Date: 24 June 2004
 To: T10 Technical Committee and SNIA OSD TWG
 From: Ralph O. Weber
 Subject: Rewrite of OSD Security and Policy/Storage Manager Models

Summary

Figure 1 — Example OSD Configuration

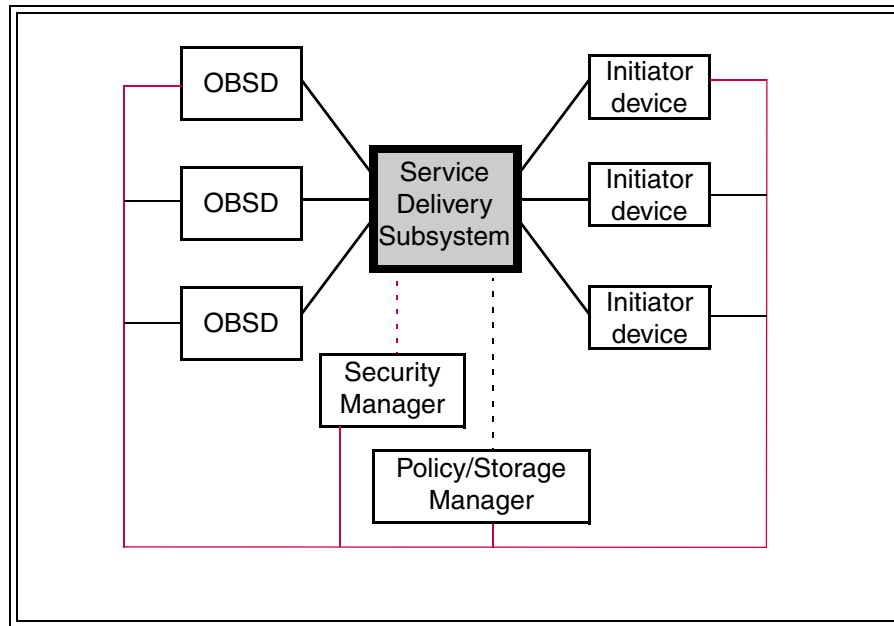
- a) Object-Based Storage Devices;
- b) Service delivery subsystem;
- c) Host systems (i.e., initiator devices);
- d) Optionally, a security manager; and
- e) Optionally, a policy/storage manager.

The security manager, if present, **secures access capabilities in cryptographically protected credentials** for OSD device servers and application clients (see 4.9). The security manager may use the service delivery subsystem and be an application client, but the security manager also may use another mechanism to communicate with the OSD device servers and application clients. When sending credentials to an application client, the security manager shall use a private, authenticated communications mechanism. The security manager may reside in the OBSD, in applications clients, or as a separate entity, but the security requirements on the communications mechanism shall not change based on the location of the security manager.

The policy/storage manager, **if present, coordinates access constraints between OSD device servers and application clients** (see 4.x).
